SUBJECT APPROVED CONCEPT REPORT

**DEPARTMENT OF TRANSPORTATION
STATE OF GEORGIA
PROJECT CONCEPT REPORT**

SR 166 Widening and Reconstruction of SR 166 and Bridges

Project Number: STP00-0021-01(024)

Typical Sections

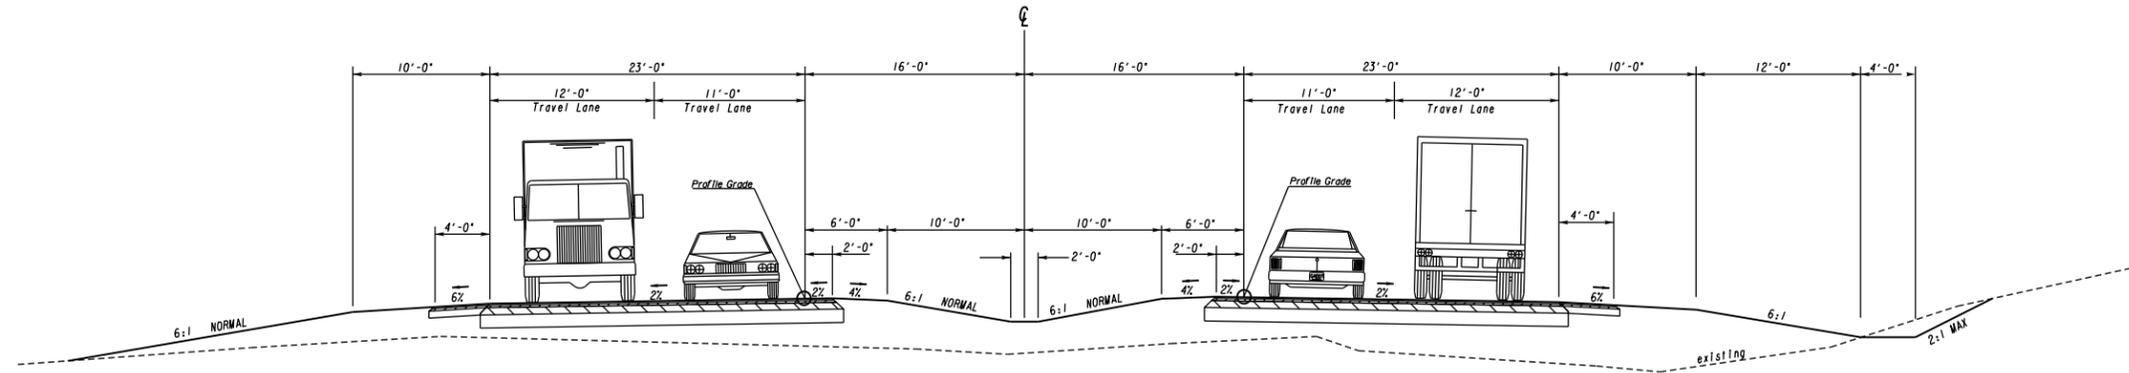
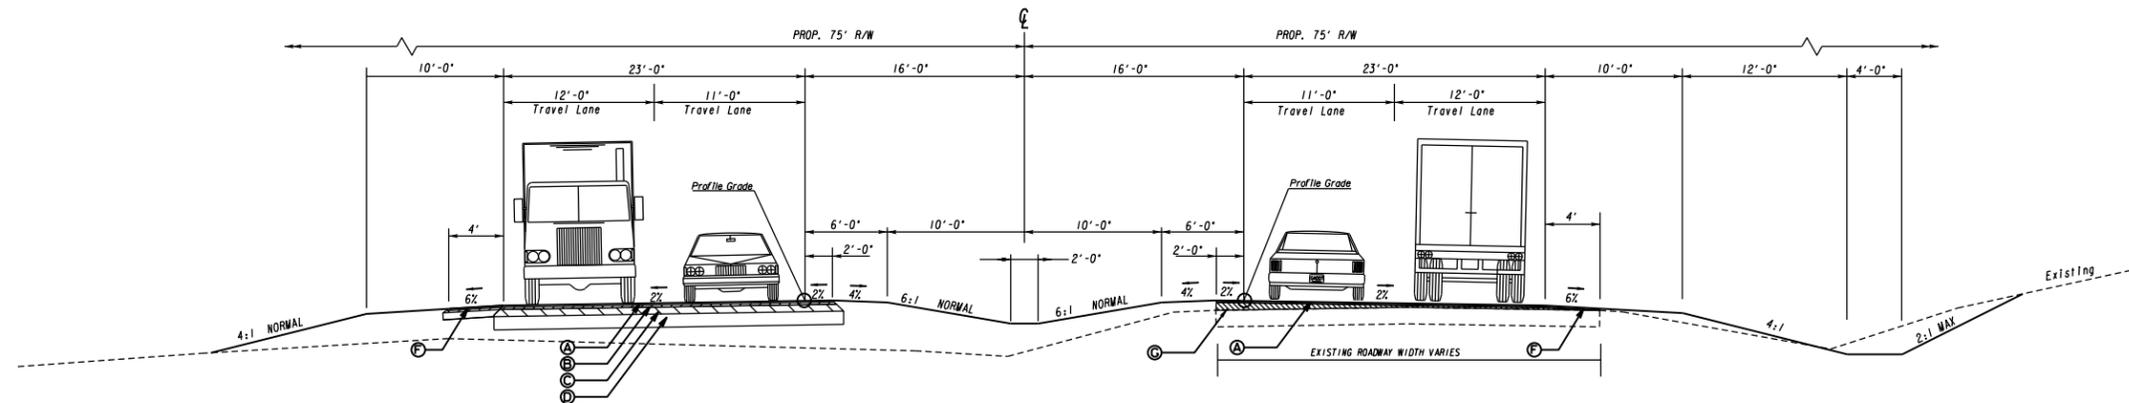
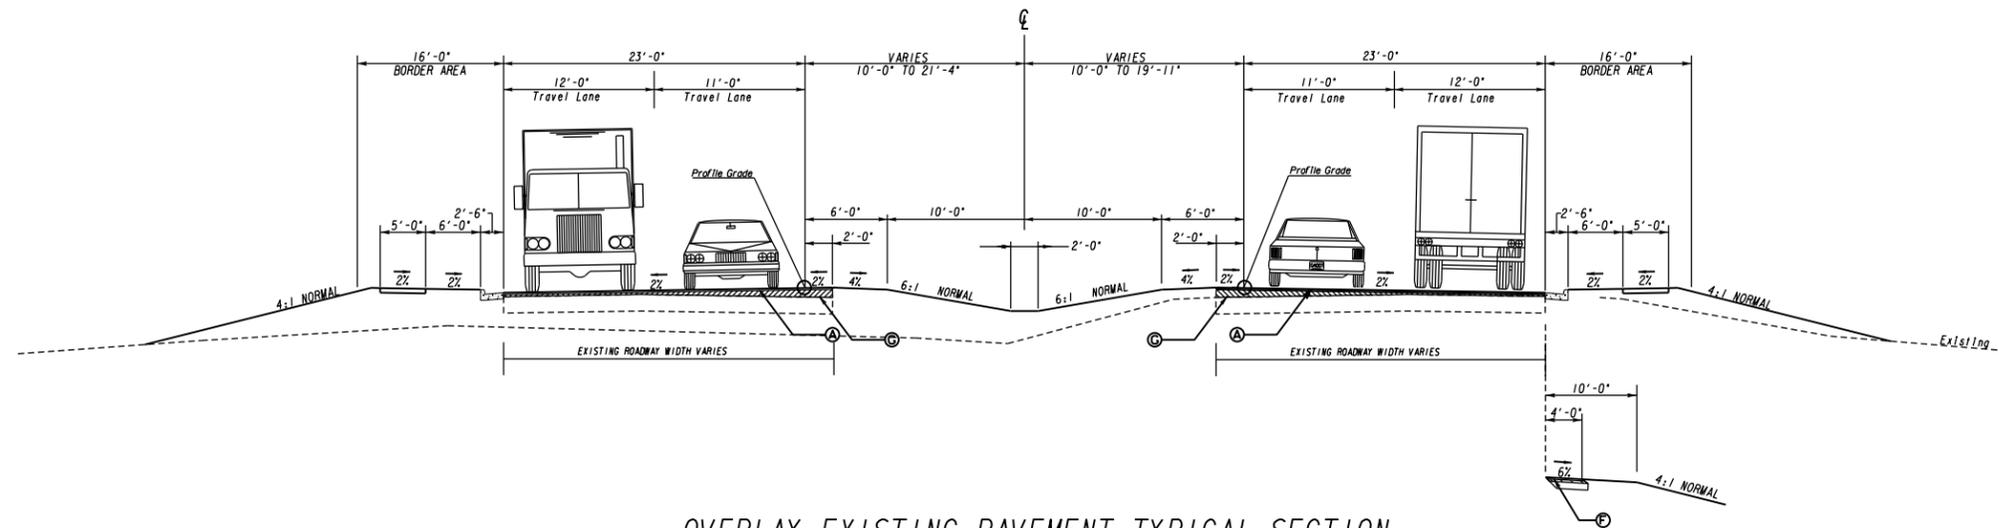
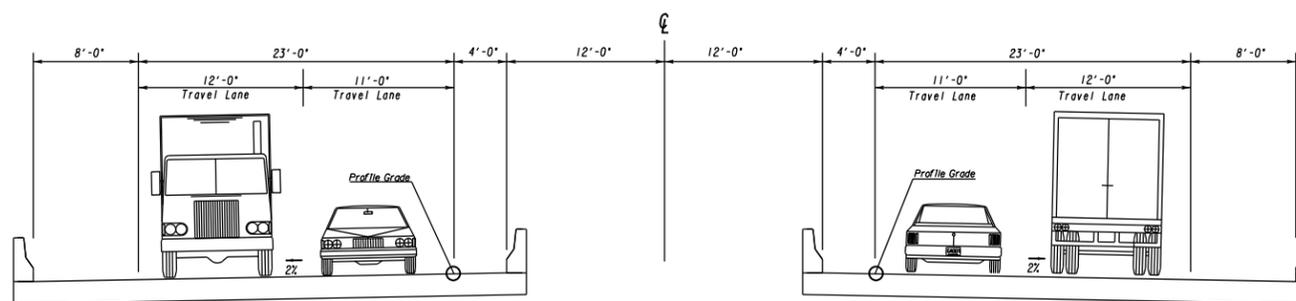
Comment: The pavement layers for the bypass section do not match those proposed for the bypass section in the Pavement Type Selection Report in the Typical Sections.

Comment: All typical sections specify a Polymer Modified 12.5 mm Superpave surface course. The ADTs in the Concept Report do not warrant the use of Polymer Modified 12.5 mm Superpave per the GDOT Guidelines for Superpave and Other Mix Types Selection.

Comment: All typical sections specify a 19 mm Superpave layer with a spread rate of 330 LB/SY (3.0-inch layer). The GDOT Guidelines for Superpave and Other Mix Types Selection directs that a 2-inch layer (spread rate = 220 LB/SY) is the optimum thickness for smoothness.

Comment: The typical sections with the 6.5-foot paved outside shoulders do not have the thickness of the GAB layer labeled.

Response: The typical sections have been updated to match the Pavement Type Selection Report. A detailed pavement analysis will be completed as part of preliminary design at which time the pavement section will be finalized.

Response: The typical sections have been updated to remove the reference to Polymer Modified pavement. A detailed pavement analysis will be completed as part of preliminary design at which time the pavement section will be finalized.

Response: The typical sections have been updated to reflect a spread rate of 220 LB/SY. A detailed pavement analysis will be completed as part of preliminary design at which time the pavement section will be finalized.

Response: At this time, it is assumed that the GAB under the pave shoulders is the same thickness, 14 inches, as the travel lanes. A detailed pavement analysis will be completed as part of preliminary design at which time the pavement section will be finalized.
